PCN# 20260324003

Updates from revision -4 to -5 for

MitySBC-A5E
All Variants

Date: March 24, 2026

4 Connect I3C Pullup enable pin and pullup circuit for I3C0 signals.

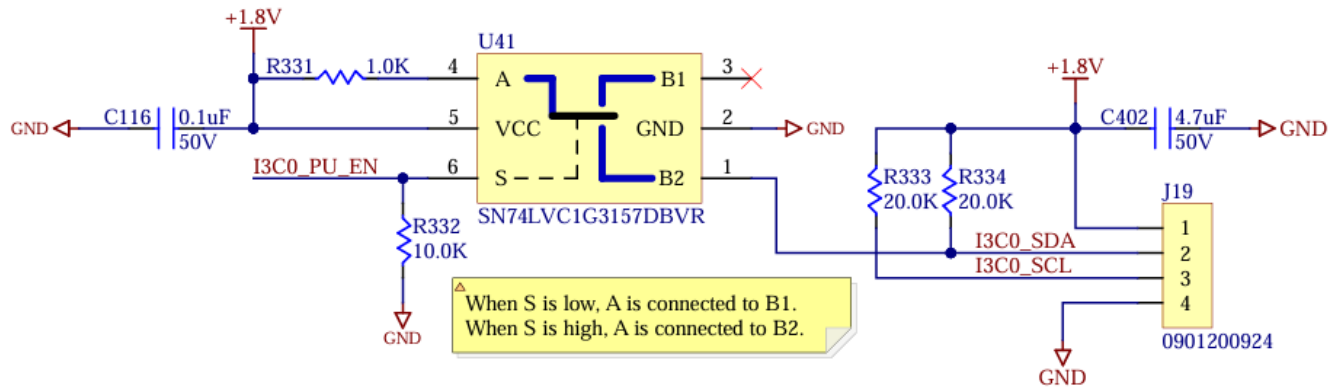
The circuitry shown below was added to the I3C0 bus on the J19 expansion connector. The I3C0_PU_EN net is tied F127 of the Agilex 5 FPGA. The ETH1_RESETN net, previously connected to F127 of the Agilex 5 FPGA, has been moved to pin T132 of the FPGA (GPIO0_IO11), previously not used.

To fully support the I3C standard, Altera requires the above circuitry to enable the pullups on the I3C bus when required.

This change allows compliance to the I3C bus on the J19 connector. Customers using the ETH1_RESETN line will need to update their firmware to use the newly assigned pin.
